Re: Response to Comments
Application for Site Plan Approval
Leachate Treatment Plant Expansion – Stage III
Waste Management of New Hampshire, Inc.
Rochester, New Hampshire

This letter serves as Waste Management of New Hampshire, Inc.'s (WMNH's) response to the Technical Review Group's (TRG) Review Comments from the October 5, 2023, meeting for the above-referenced Site Plan application. For clarity, the TRG comments are presented below in italics followed by WMNH's responses.

LEACHATE TREATMENT PLANT EXPANSION STAGE III WASTE MANAGEMENT OF NEW HAMPSHIRE, INC. TURNKEY RECYCLING & ENVIRONMENTAL ENTERPRISES

PROPOSED SITE PLAN

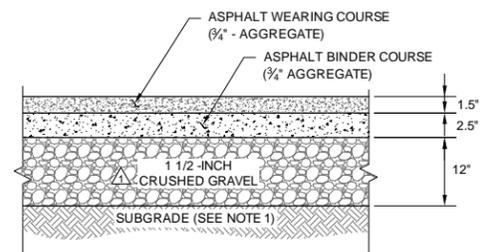
- 2. The project narrative discusses stormwater management and that some flows will be contained within the below grade containment system and other flows directed directly to existing SW swale. Please show the existing and proposed limits of the containment system and provide contour labels so we can verify stormwater flow directions.*

Response: The existing limits of the containment system are shown on Sheets 3 and 4 of the revised drawings. The proposed final limits of the containment system are shown on Sheet 4 of the revised drawings. Additionally, contour labels have been added to the drawings.

- Sheet 1 - updated the legend.
- Sheet 3 - added contour labels and the limit of the existing containment.
- Sheet 4 - added contour labels, the limit of the existing and proposed containment, revised the access into the tank area, relocated the ferric chloride tank to inside the UF Building expansion; relocated the bulk methanol storage tank to in front of the UF building; with the relocation of the tanks shorten the proposed water line; added a concrete slab under the proposed rental chiller staging area; included guardrail on the SW side of edge of pavement and added the word 'proposed' to MBR #1 & #2 Internal Recycle Pumps in Enclosure labels.

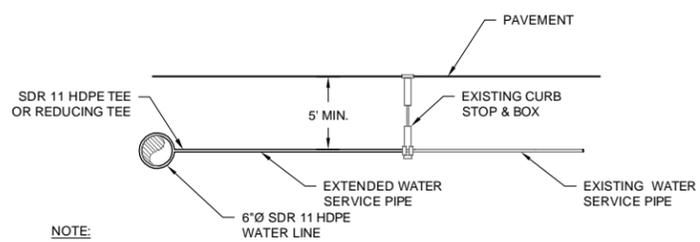
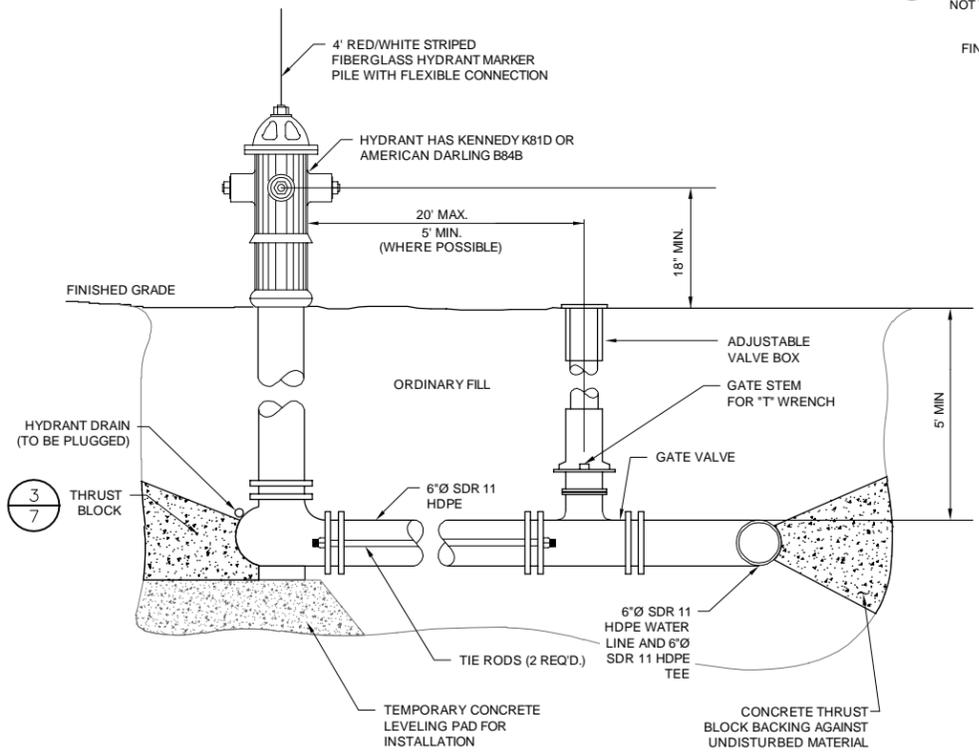
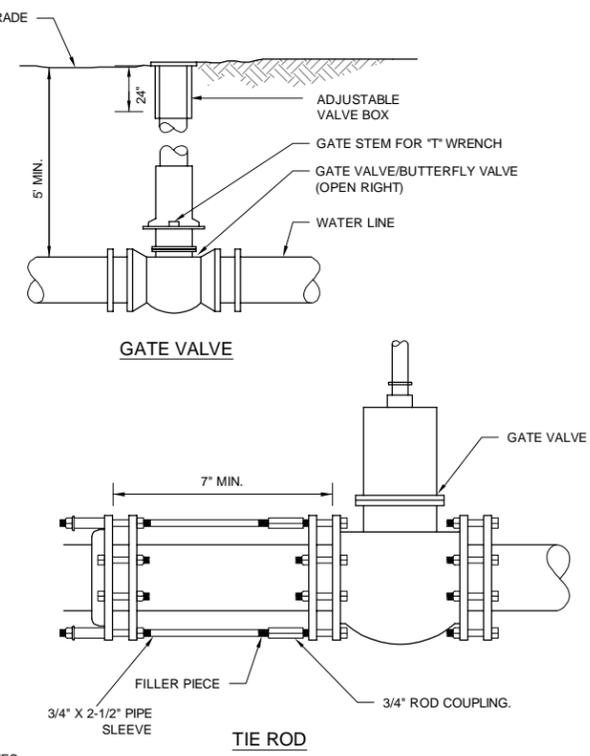
- 1. Please show details on water line connections and hydrant details (per city standards).*

Response: Water line connection and hydrant details are included on Sheet 7 of the revised drawings. The revised drawings are attached.

- Sheet 5 – revised the specified gravel for the pavement and crushed gravel section to be consistent with aggregate materials available at the site.
- Sheet 7 – added the waterline connection and fire hydrant details.

BUILDING FLOOR PLAN

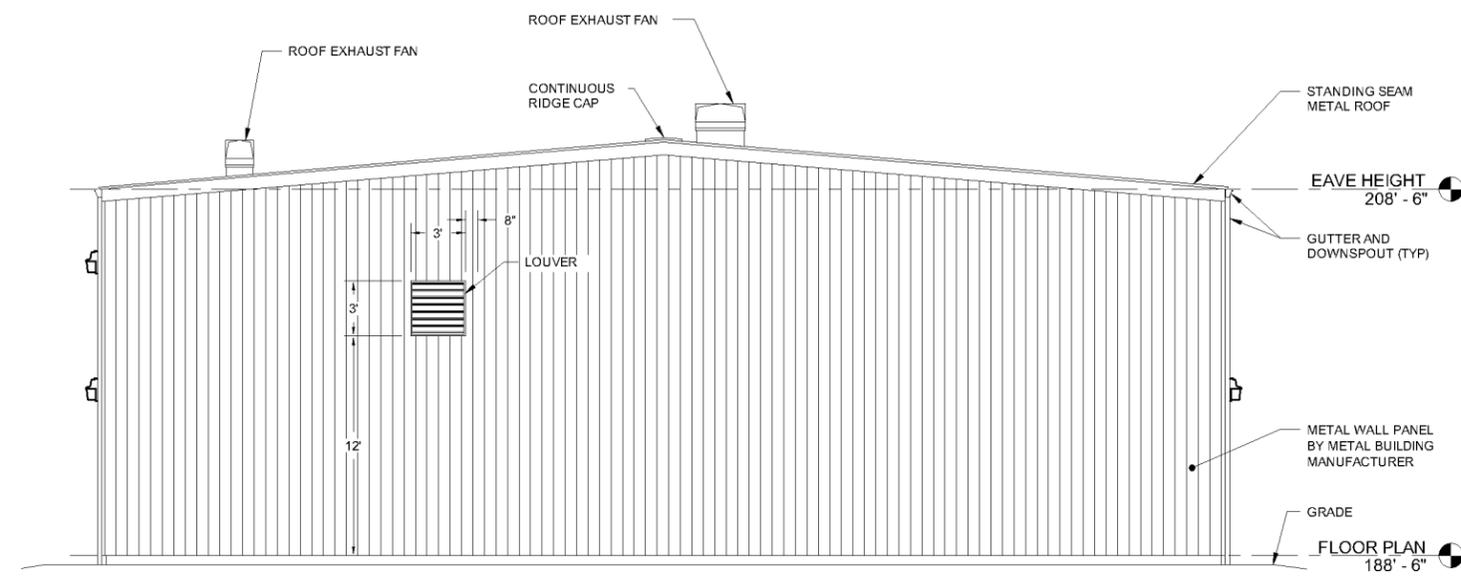
- 3. Please provide information regarding planned environmental controls for the bulk storage of ferric chloride.*

Response: The storage tank for the ferric chloride will be a double contained HDPE tank. WMNH is proposing to relocate the ferric chloride tank to inside the UF building expansion

addition. By placing the double-contained tank inside the building additional containment and protection of the environment is provided.

- Sheet 8 – relocated the ferric chloride tank inside the UF building addition and revised the exterior and interior doors to work with the ferric chloride tank location.
